## SERVICE BULLETIN

**APPLICABILITY:** 2013MY BRZ

**NUMBER:** 02-151-14

**SUBJECT:** Revised Valve Train Parts to Reduce a Warm Engine  
 Tapping Sound from the Left Cylinder Head

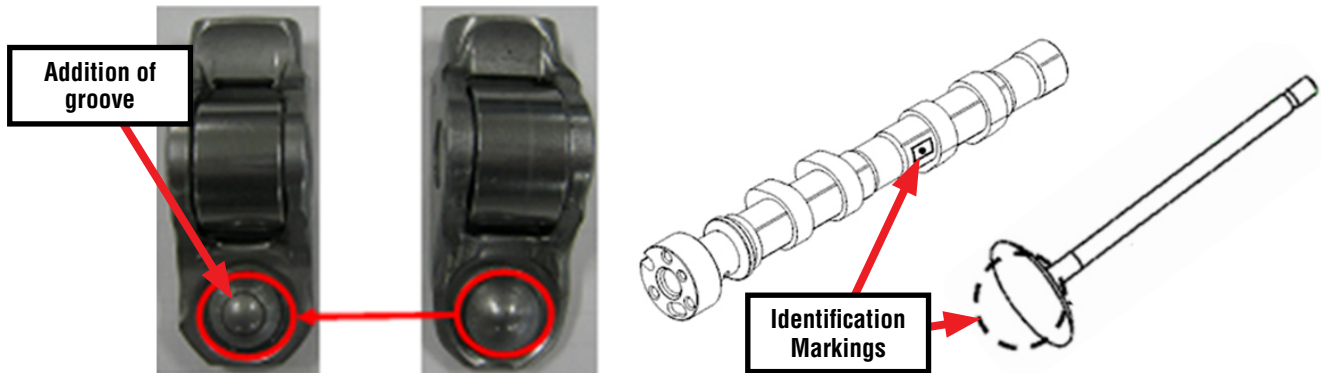
- Design change to the valve rockers
- Camshaft profile change
- 1.65mm longer intake and 2.47mm longer exhaust valve stem lengths

The illustrations below show additional information about the changes to the valve rockers, camshafts and valves to help readily distinguish them from the previous version parts.
